From: Scott Fitinghoff <sfitinghoff@cornerstoneearth.com>
Sent: Thursday, December 27, 2018 10:33 AM
To: Sherry Liu
Cc: Jack Chamberlain; Camille Leung; Steve Monowitz
Subject: RE: BLD2016-00160, 2185 COBBLEHILL PL, LOT 9 SAN MATEO
Attachments: 230-1-6 Geotechnical Consultant Review Form Part 1 Signed 12-27-18.pdf

Subject: BLD2016-00160, 2185 COBBLEHILL PL, LOT 9 SAN MATEO

The Geotechnical Section of Planning and Building Department has conditionally approved the 11/21/2018 plans submitted for Lot 9, which included the riprap details for Lot 10, and 11/27/2018 plans submitted for Lot 11. Please make sure that the final riprap details for Lot 10 match the approved ones in Lot 9.

Date: November 15, 2018
Project No.: 230-1-6
Prepared For: Mr. Jack Chamberlain
TICONDEROGA PARTNERS, LLC
655 Skyway, Suite 230
San Carlos, California 94070
Re: Geotechnical Consultation and
Response to County of San Mateo
Geotechnical Comment
Highlands Estates (Lots 9 and 10)
San Mateo, California
County of San Mateo Geotechnical File Number
BLD2016-00158--00164

LOT 11
UTILITY PLAN
 SCALE: 1"=10'

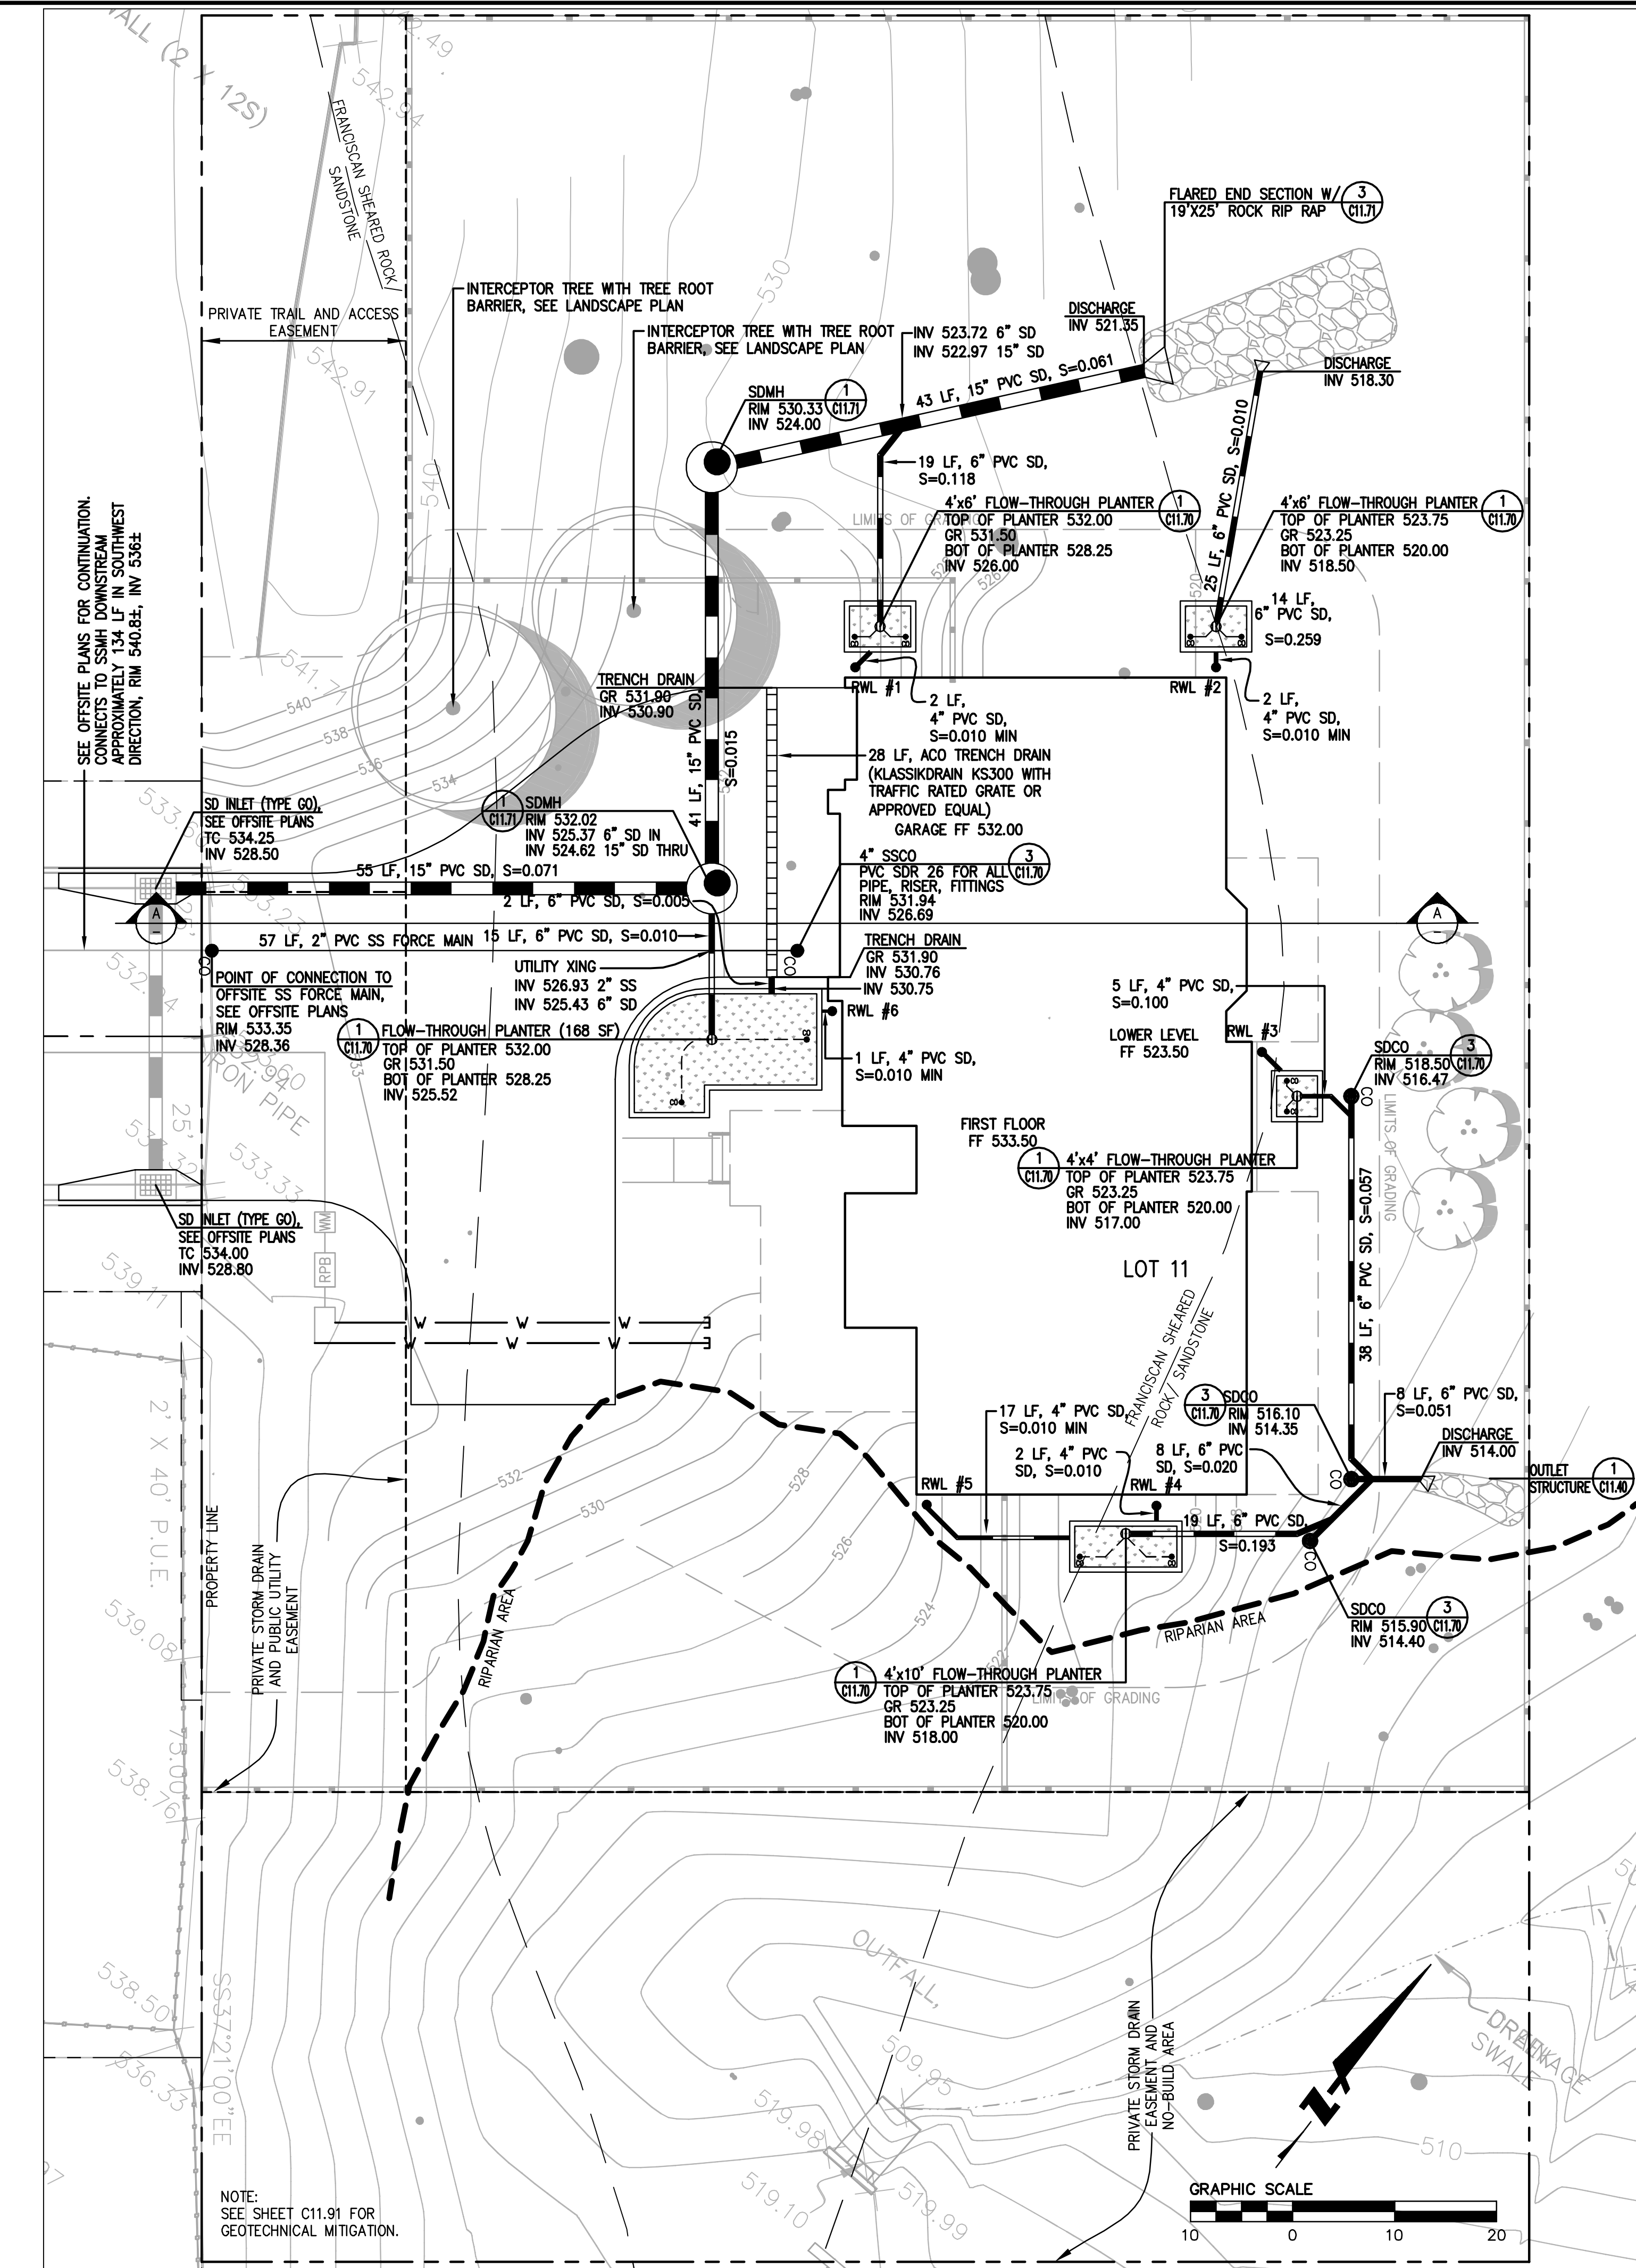
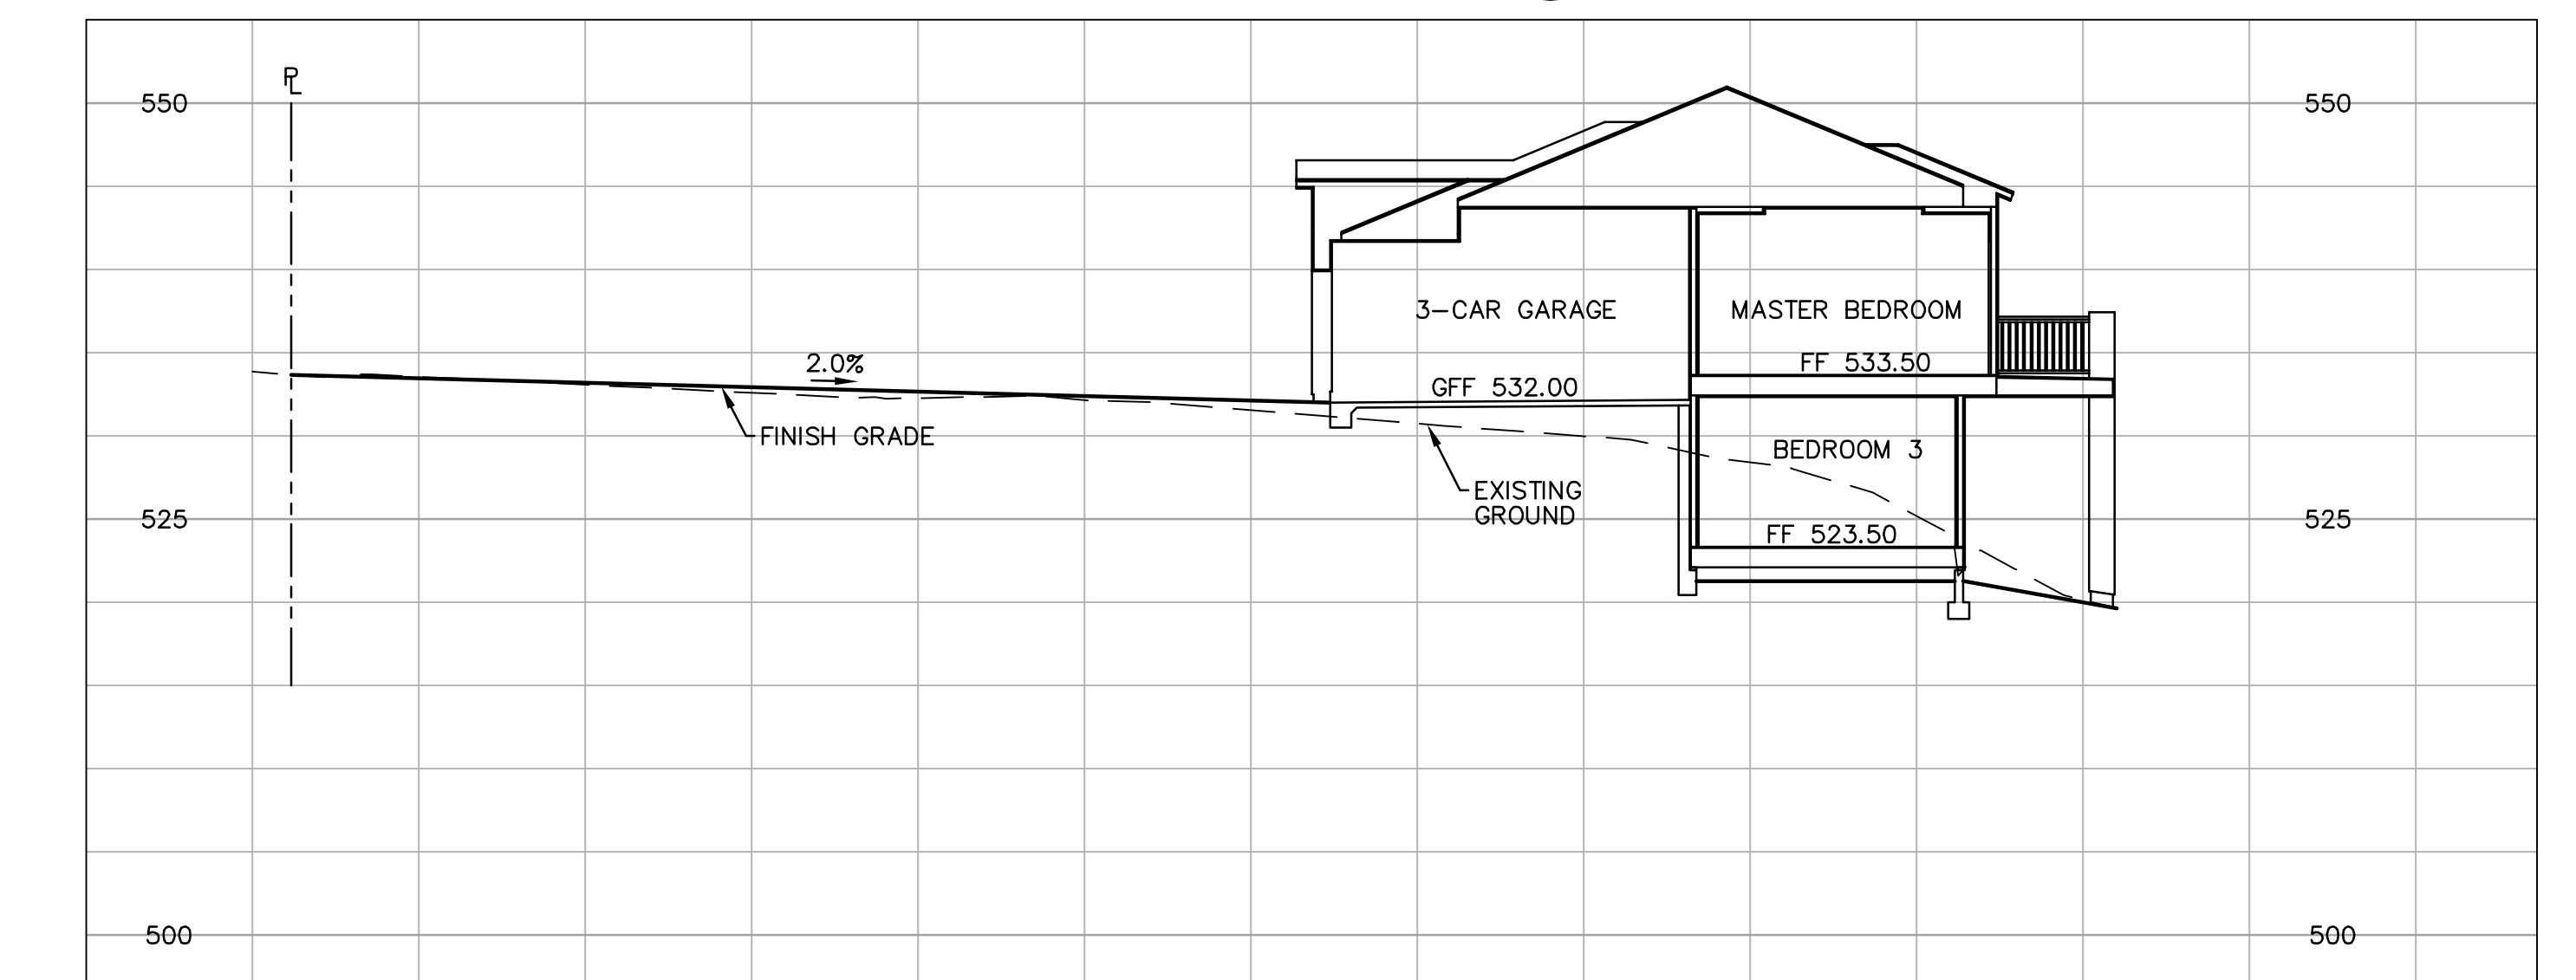
- 1. In Cornerstone's report of 10/30/15 p.18, the geotechnical engineer of record recommended existing fills (shown in Figure 9 the same report) to be removed in the proposed driveway and slab-on-grade. Please estimate the volume of the removal, as well as any fill that may be required following removal.*

Response: Please see revised sheets C11.40 and C11.71 for outlet rock riprap keyed into the sandstone. Please also see revised sheets C11.30 and C11.40 for approximate location of sandstone in plan-view relative to the location of outfall.
